III. Revisions, Clarifications, and Corrections to the Draft EIR

This section of the Final EIR provides changes to the Draft EIR that have been made to revise, clarify, or correct the environmental impact analysis for 1360 N. Vine Street (the Project). Such changes are a result of public and agency comments received in response to the Draft EIR and/or additional information that has become available since publication of the Draft EIR. The changes described in this section do not result in the Project creating any new or increased significant environmental impacts.

Revised Figure II-7
Residential Option Building Section

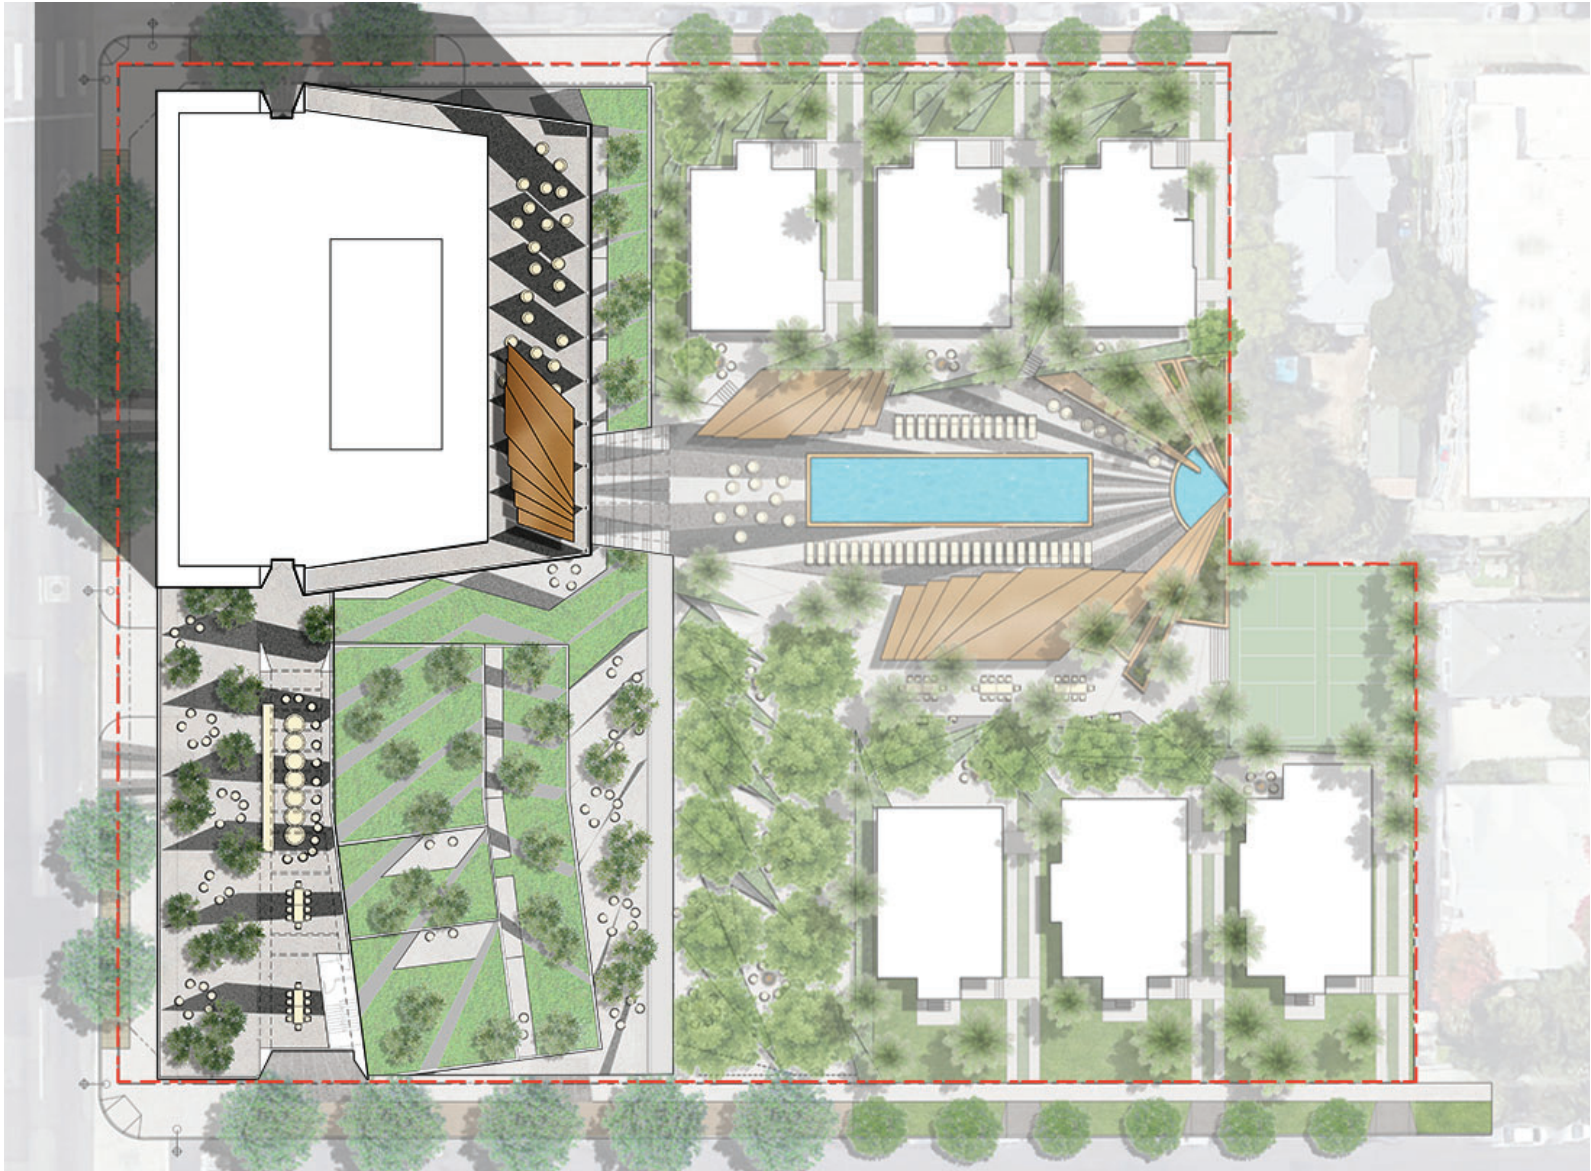
As shown in Revised Figure II-7 on page ~~II-15-III-14~~ of the Final EIR, the Residential Option would develop a new ~~32~~ 33-story high-rise building with four levels of subterranean parking. The maximum height of this new building would be ~~360~~ 388 feet 4 inches when accounting for rooftop mechanical equipment.⁸ As shown in Revised Figure II-8 on page ~~II-16, III-15~~ of the Final EIR, the ground floor of the building would include grocery and neighborhood-serving commercial retail uses that would front Vine Street and Afton Place. The ground floor would also include vehicular access driveways, commercial and residential truck loading, a residential lobby and mailroom, and service and corridor areas. In addition, outdoor common open space would also be located on the ground floor between the new building and the rehabilitated bungalows. Above the ground floor, the Project includes a mezzanine level with additional space for the grocery store and retail uses, and common resident areas. Level 2 would include ~~the a full~~ second level of grocery store uses. Levels 3 through 9 and Levels 11 through 32 would contain the residential units. Level 10 would include additional indoor and outdoor amenities. Level 3 would a 6,000-square-foot resident amenity space and Level 11 would include a large outdoor resident deck with seating areas and landscape. Level 33 would contain a 4,200-square-foot interior residential amenity space and exterior roof deck. Overall, the Residential Option would comprise approximately 484,421 square feet of floor area.

Section II, Project Description, page II-15, replace Figure II-7 with Revised Figure II-7 on page III-15:

Revised Figure IV.G-2
Zoning Designations for the Project Site and Vicinity

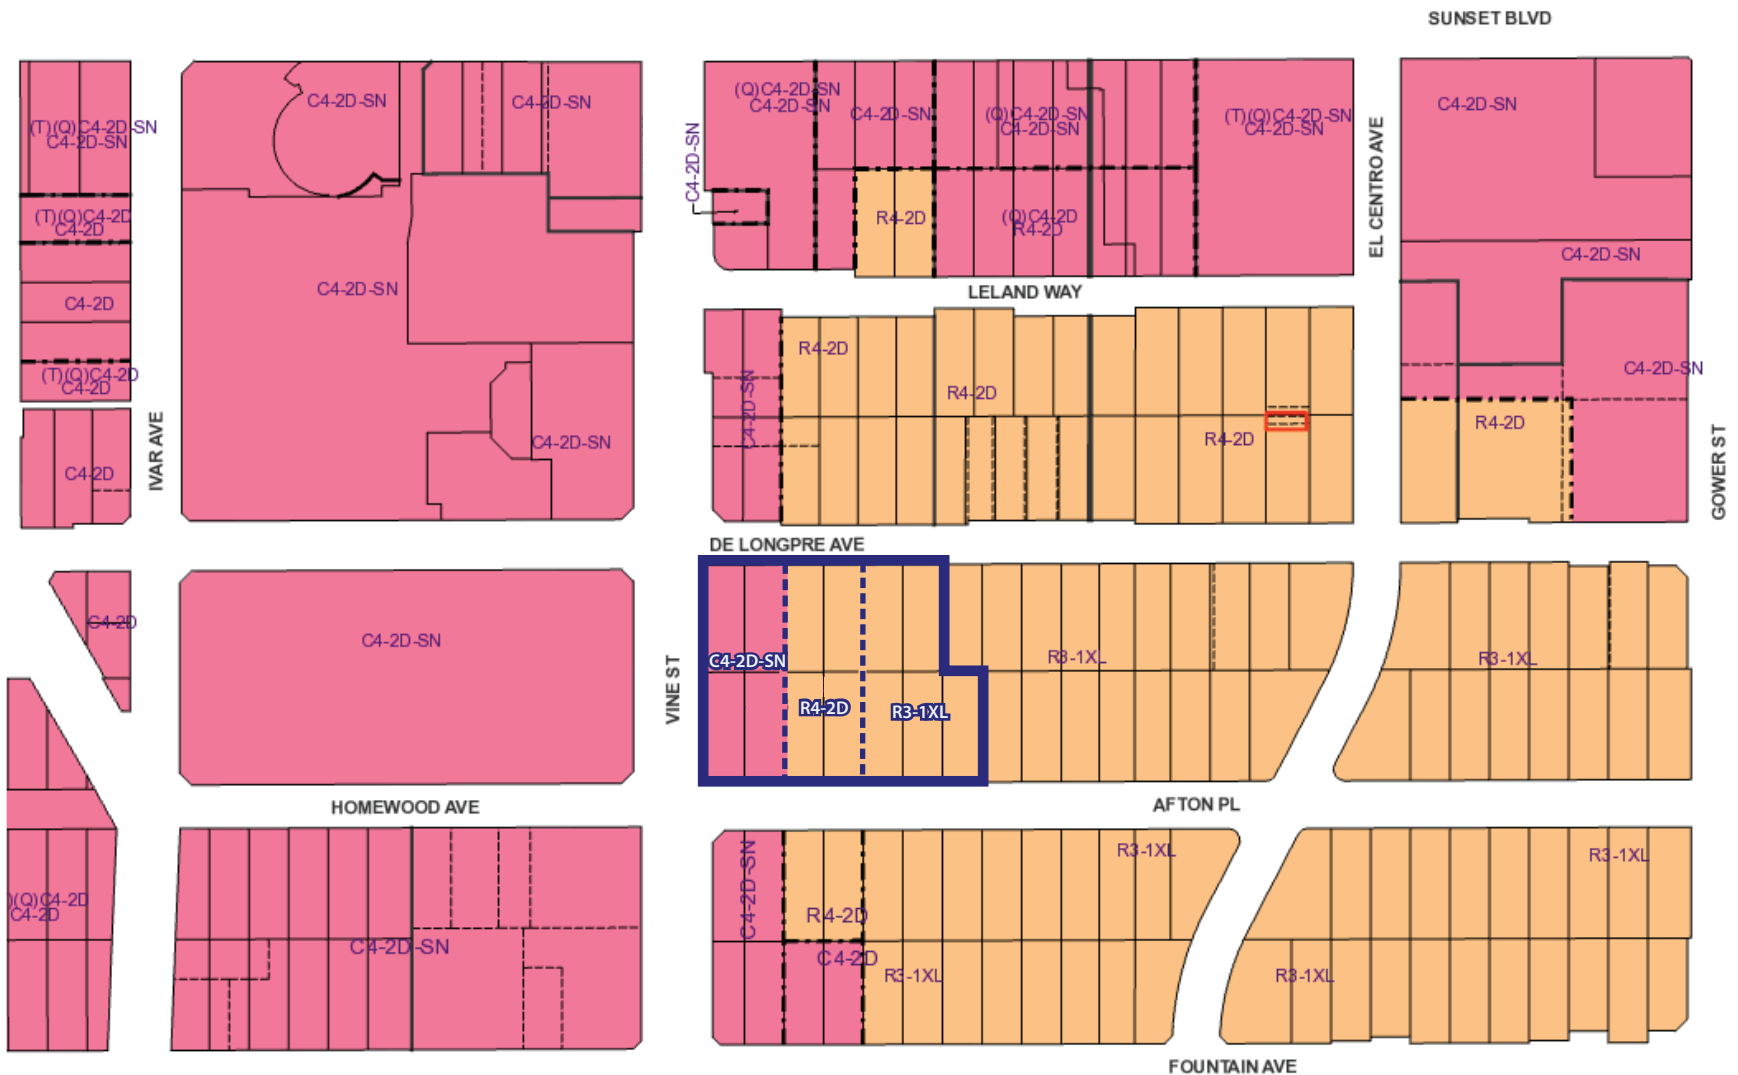
First, at the time the Draft EIR was published, the City's ZIMAS website indicated that one of the parcels (APN 5546-022-013) in the northern portion of the Project Site was zoned (T)(Q)C2-2D. However, this was incorrect because the Zone Change ordinance (ORD 168,948) was not effectuated within the required six years after it was approved. The parcel zone is now corrected on ZIMAS and is zoned R4-2D. This will not affect the Project or the analysis in the Draft EIR, as the Applicant is seeking to rezone this parcel to [Q]C4-2-SN.

Provided below are revisions to the Project Description that apply to the entirety of the Draft EIR. In addition, as noted below, Figure IV.G-2 in Section IV.G, Land Use, is replaced with Revised Figure IV.G-2 on page III-27 of this Final EIR.

Section IV.G, Land Use and Planning, page IV.G-11, replace Figure IV.G-2 with Revised Figure IV.G-2 on page III-27 of this Final EIR:
